### **REMARKS**

RESPONSE TO OFFICE ACTION OF SEPTEMBER 8, 2005  
Serial No. 10/524,332, page 6

*Fig. 1a*  
PRIOR ART

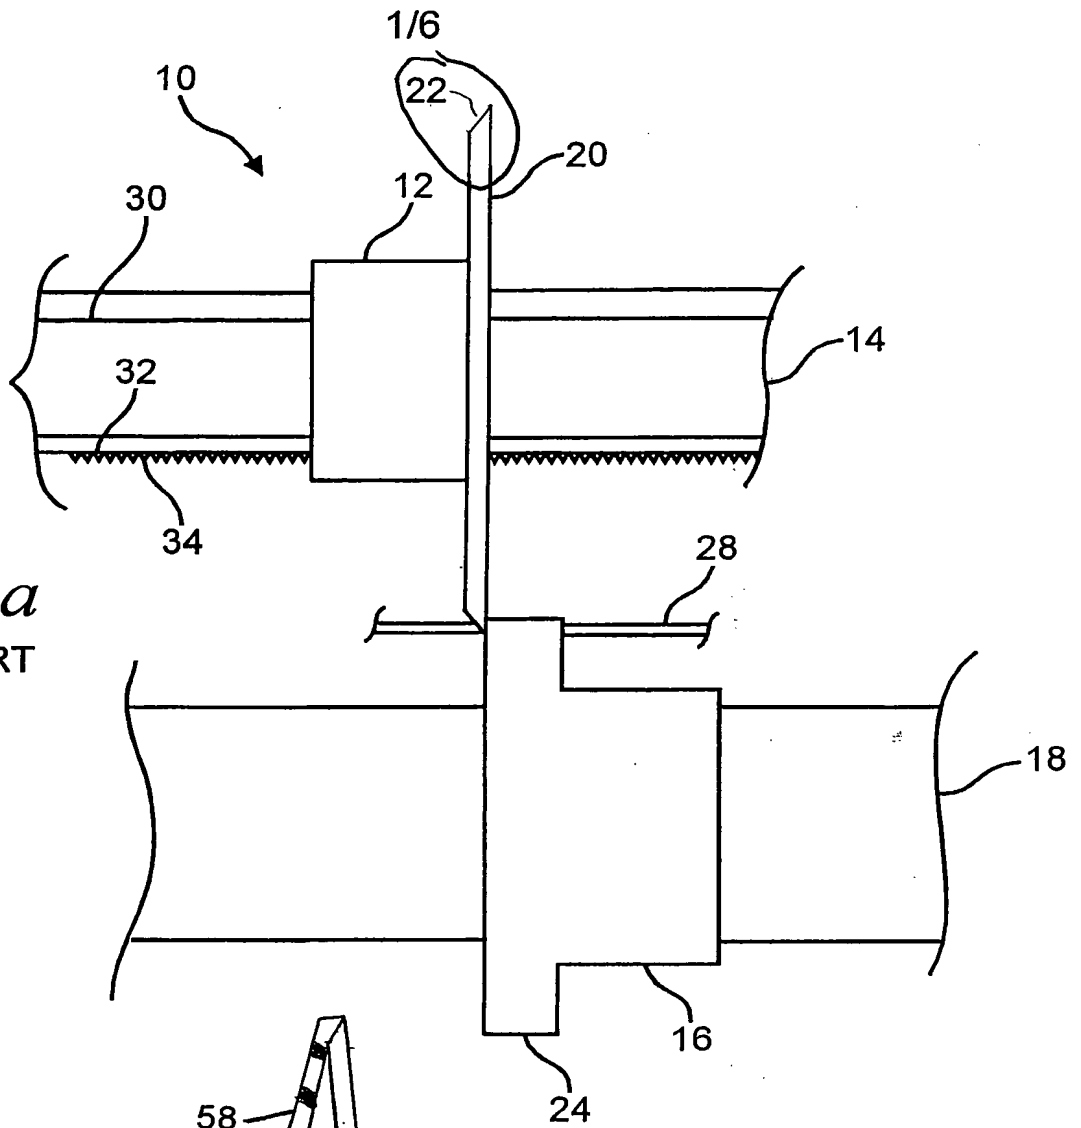
Finally, Applicant submits herewith inked drawing (all figures) to replace the original penciled drawing. Two inadvertent, but obvious errors have been corrected in FIGURE 1 (as marked in red). In FIGURE 1a, the blade 20 is symmetrical (as now shown) with respect to the rail 14. In FIGURE 1b, the cross-hatching of the slitter unit 24 has been corrected. Acceptance is respectfully requested.

*Fig. 1b*  
PRIOR ART

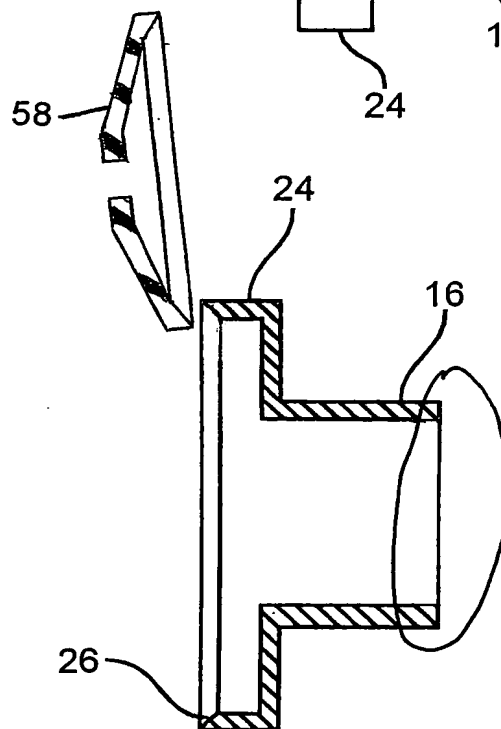
In the Office Action, the Examiner rejected this application on several grounds relating to the insufficiency of the disclosure. For example, the drawings were found objectionable for failing "to show the relationship between the guiding wheel (58) and the collar (24) as described in the specification." In a similar fashion, the Examiner objected to (i) the abstract; (ii) the specification; and (iii) the claims. Additionally, the Examiner rejected the claims under Section 112, second paragraph, for certain informalities.

While the Applicant acknowledges that the engagement of the lower slitter unit 24 and grinding wheel 58 for the purpose of sharpening is not shown in the original drawing, it is unnecessary.

To expedite prosecution, however, Applicant has amended FIGURE 1b to show the typical, conventional engagement of the cutter unit and guiding wheel, as requested by the Examiner. The description of that figure has also been amended to reflect the conventional nature of the engagement. Given these circumstances, no new matter is presented.
